DEPARTMENT OF TRANSPORTATION
National Highway Traffic Safety Administration
Docket No. NHTSA-2010-0053
Visual-Manual NHTSA Driver Distraction Guidelines
For In-Vehicle Electronic Devices

ACTION: Notice of Federal guidelines.

This notice announces the issuance of the final version of the first phase of the NHTSA Guidelines. This first phase applies to original equipment (OE) in-vehicle electronic devices used by the driver to perform secondary tasks (communications, entertainment, information gathering, navigation tasks, etc. are considered secondary tasks) through visual-manual means (i.e., the driver looks at a device, manipulates a device-related control with his or her hand, and/or watches for visual feedback).

Figure 2: Drawing of Slide Presented by Toyota at NHTSA Technical Workshop¹³⁶

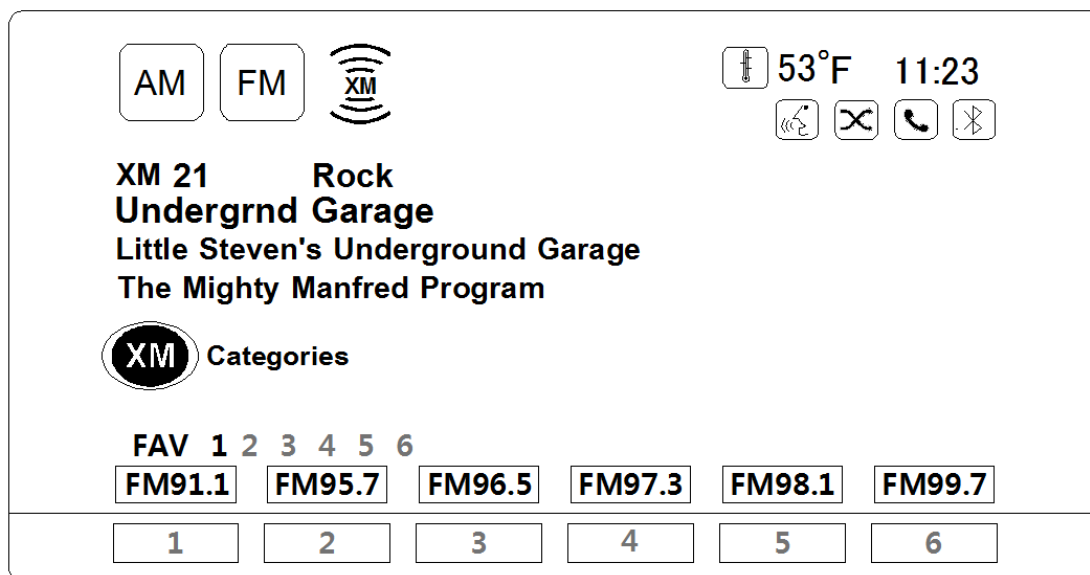
How do we apply the 30-character limit to this display? If it means a whole display can only contain 30 characters, if you look at just the six preset buttons, each preset button has five characters. So once we have the presets presented to the user, we can't give them any other information about what the radio is doing. If you pick any one element within this display, you quickly exceed a 30-character limit ...¹³⁵

Where should the 30 character limit be applied to this display?

Mr. Foley then pointed out that the information conveyed by this display is easily grasped and that drivers do not have to read each individual letter to understand what is being transmitted by this display.
